# Access Compliance Report

## Public Rights-of-Way

### (Curb Ramps)

Intersection ID: 47136	Main Street: DARLINGTON_RD	Cross Street: HABITAT_MANOR_DR	Location: NE
ADA ID: 744D72328C7E	Ramp Type: PerpDiag	Initial Pass/Fail: Fail	Overall Compliance: No
Severity Score: 21.25			
Codes/Mitigation Info/Possible Solution		Field Measurements/Component Compliance

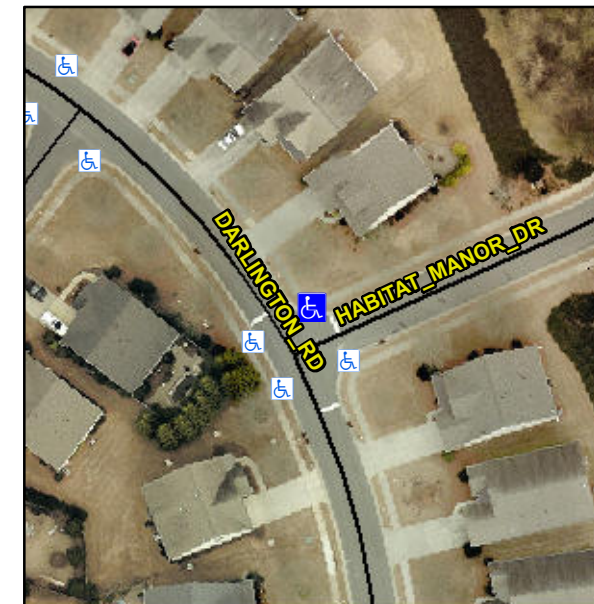
**Not Found, R304.5.1, R304.5.3**

Compliance	Description	Data	Compliance	Description	Data
N/A	Ramp Length (in)	48.0	Yes	Ramp Slope (%)	7.2
No	Ramp Width (in)	36.0	No	Ramp XSlope (%)	6.2
N/A	Flare Type LT	N/A	N/A	Flare Type RT	N/A
N/A	Flare Slope LT (%)	N/A	N/A	Flare Slope RT (%)	N/A
N/A	Flare Traversable LT?	N/A	N/A	Flare Traversable RT?	N/A
N/A	Landing Length (in)	N/A	N/A	DWS Provided?	N/A
N/A	Landing Width (in)	N/A	N/A	DWS Contrast?	N/A
N/A	Landing Slope (%)	N/A	N/A	DWS Length (in)	N/A
N/A	Landing X Slope (%)	N/A	N/A	DWS Full Width?	N/A
N/A	Landing Curb? (Y/N)	N/A	N/A	DWS Offset (in)	N/A
N/A	Shared Landing?	N/A			
N/A	Gutter Ponding?	N/A	N/A	Gutter Slope (%)	N/A
N/A	Gutter Lip Ht (in)	N/A	N/A	Gutter X Slope (%)	N/A
N/A	Painted X Walk1?	No	N/A	Painted X Walk2?	No
	X Walk 1 Direction	To W		X Walk 2 Direction	To S
N/A	X Walk 1 Width (in)	N/A	N/A	X Walk 2 Width (in)	N/A
	X Walk 1 Slope (%)	5.3		X Walk 2 Slope (%)	0.4
	X Walk 1 X Slope (%)	1.7		X Walk 2 X Slope (%)	6.4

**Remove & Replace Curb Ramp With Two New Directional Ramps or Equivalent.**
